Subject OPOG Responses to EPA 2-8-06 MIP/SVS Comments

Responses to EPA Comments Dated February 8, 2006
On-Site Soils RI/FS Work Plan Addendum No. 2
Summary of Initial Findings from Soil Vapor and MIP Sampling
(CDM, January 27, 2006)

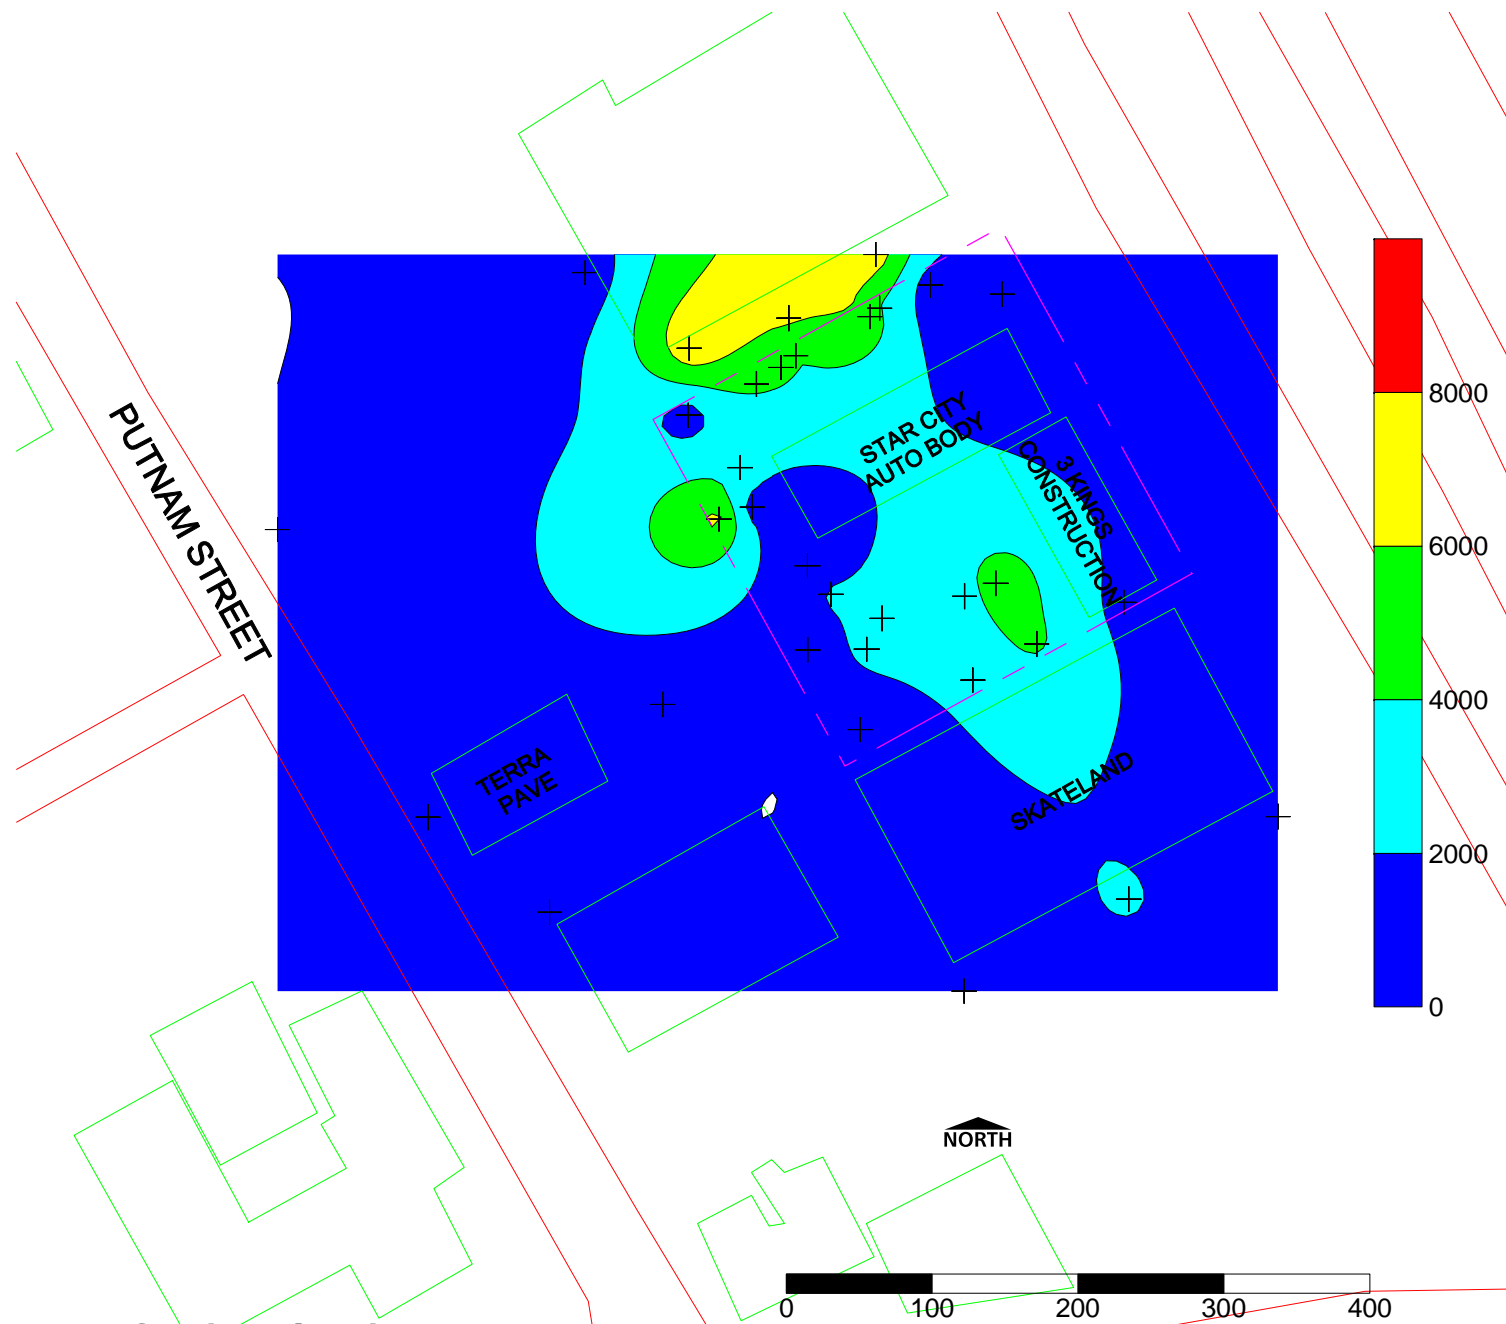
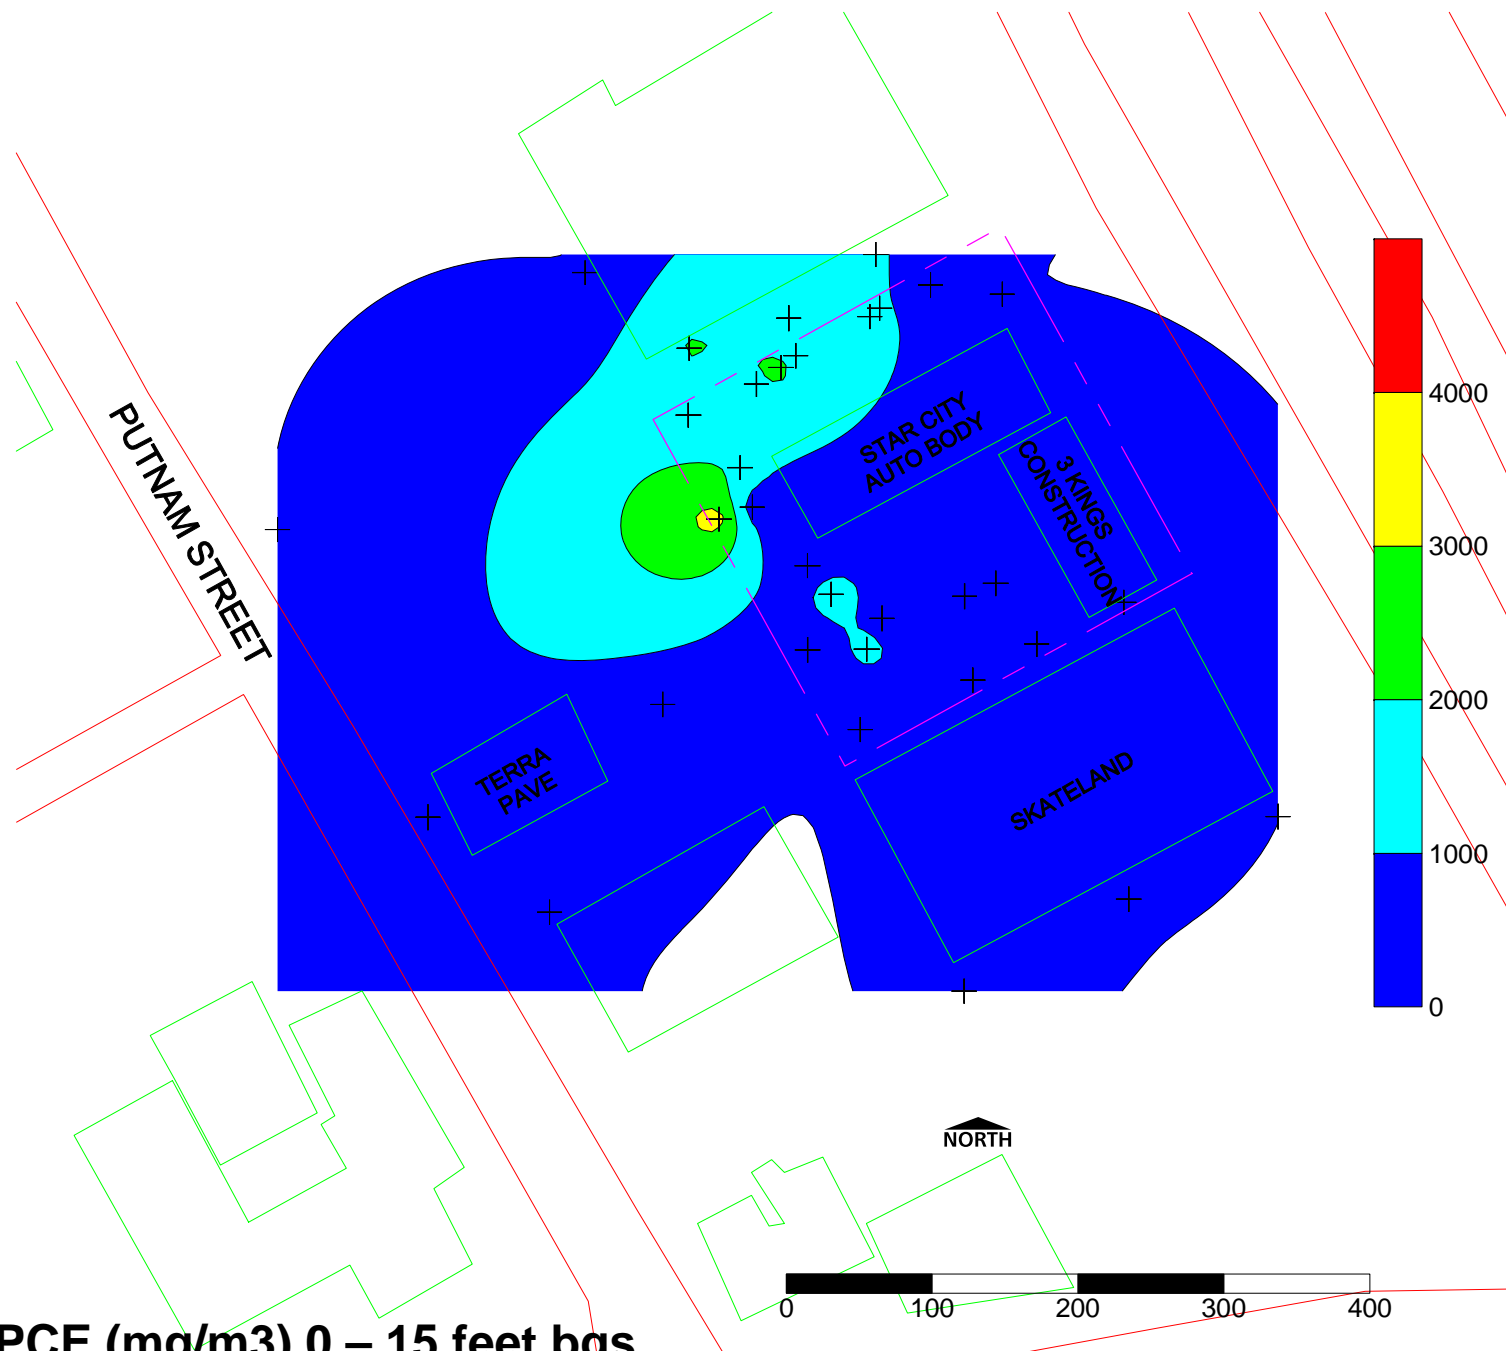
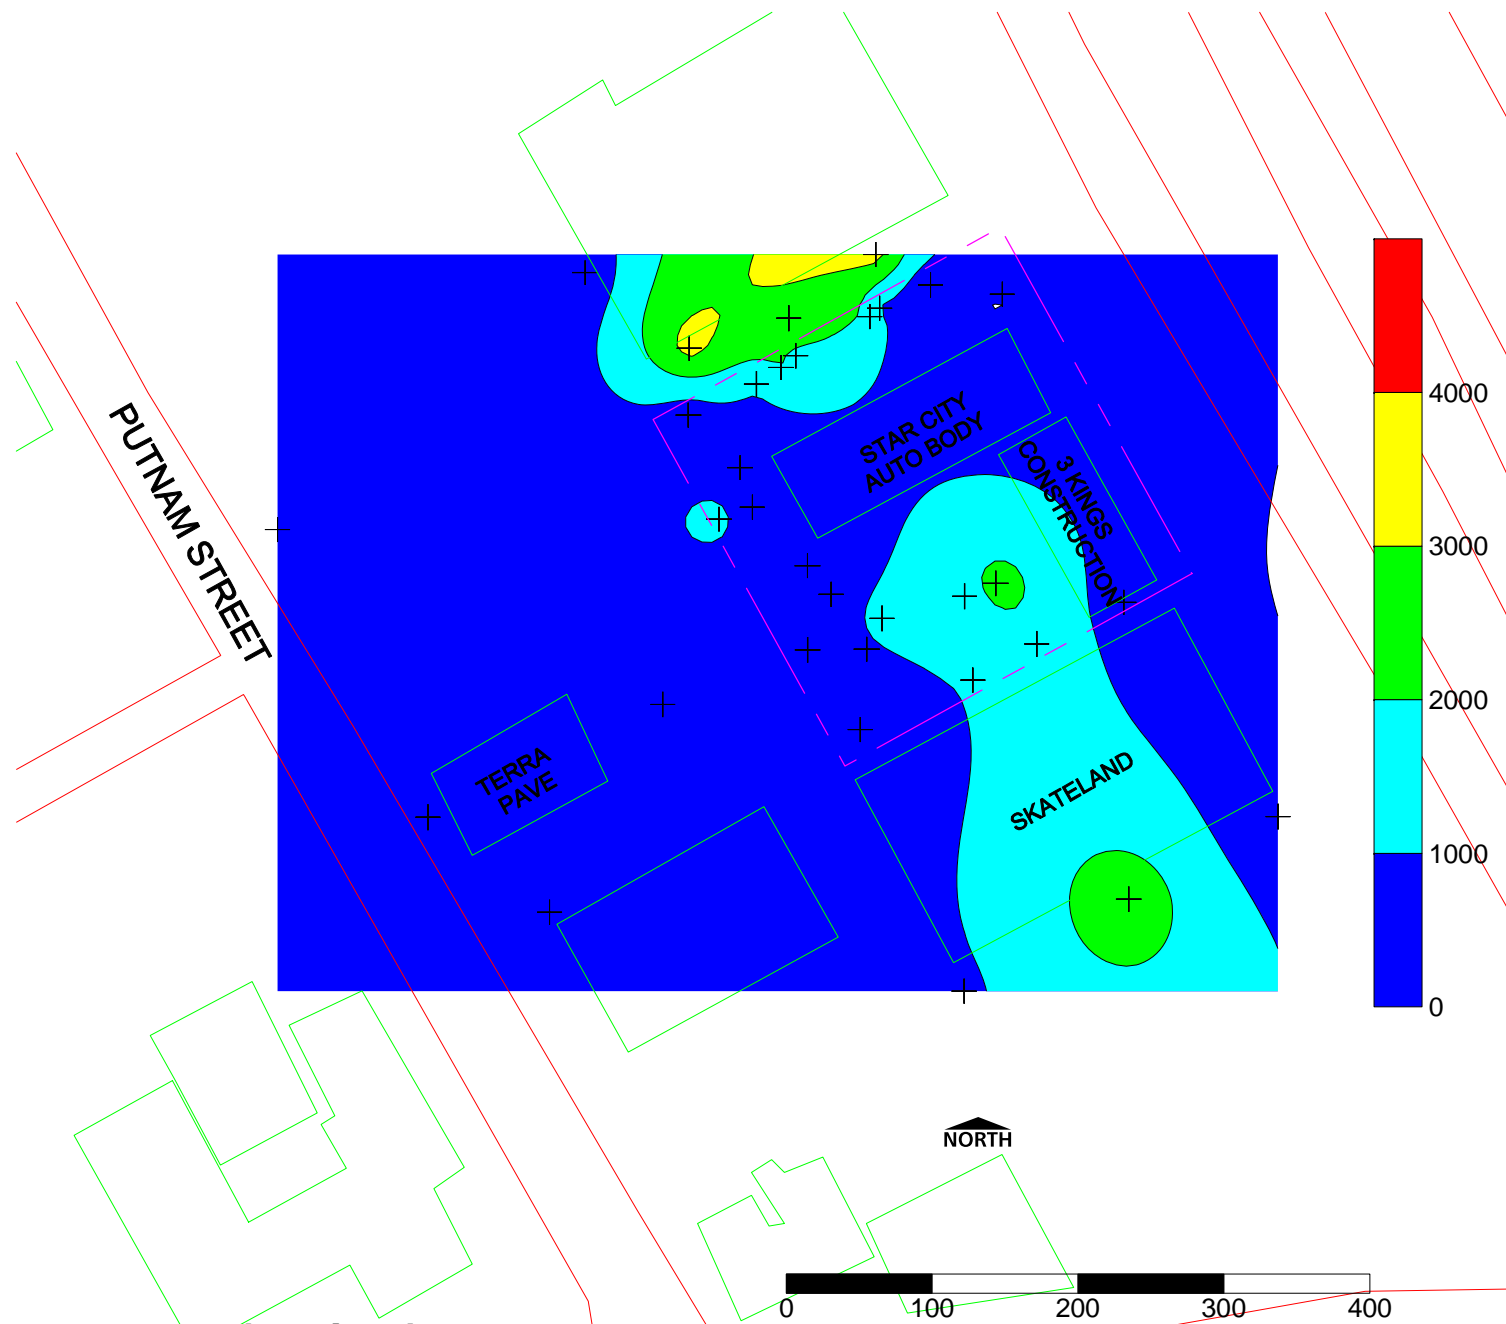
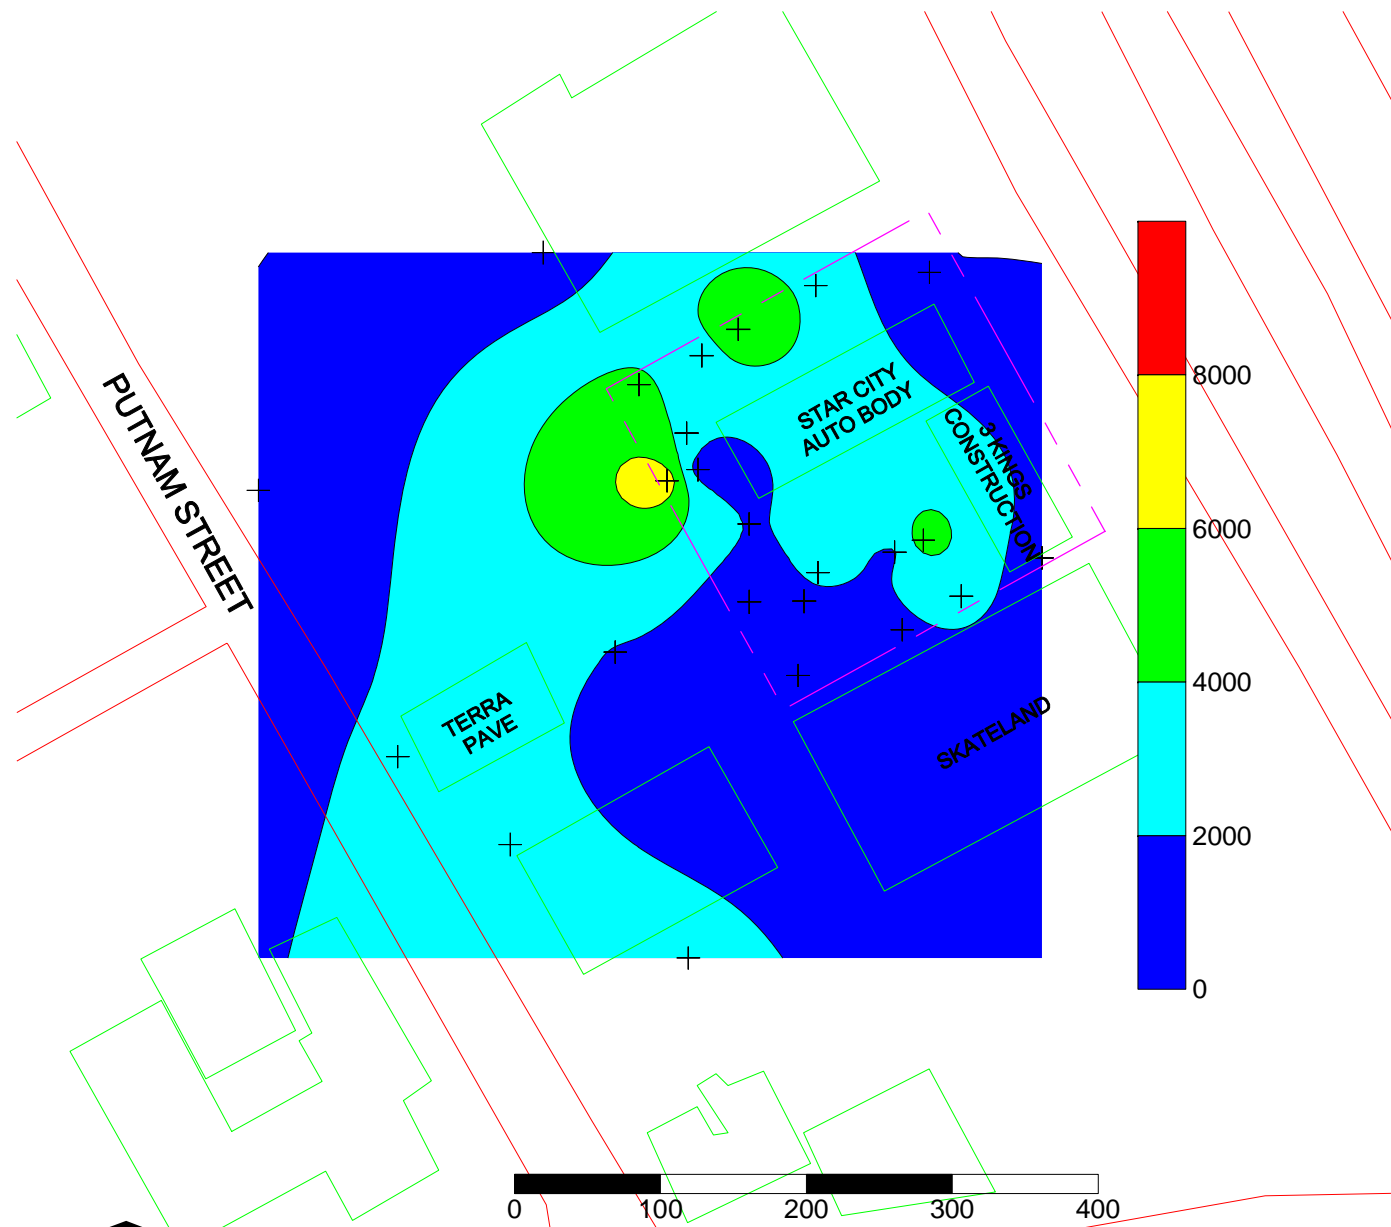
8. Prepare contour maps for total VOCs, PCE, and Freon 113 (plus any other compounds that OPOG/CDM selects) in addition to the pie chart maps (Figures 19 to 22). The contours will indicate potential source areas as well as locations where additional sampling is needed.

Response: Contour maps have been prepared and are provided in the attached PowerPoint file.
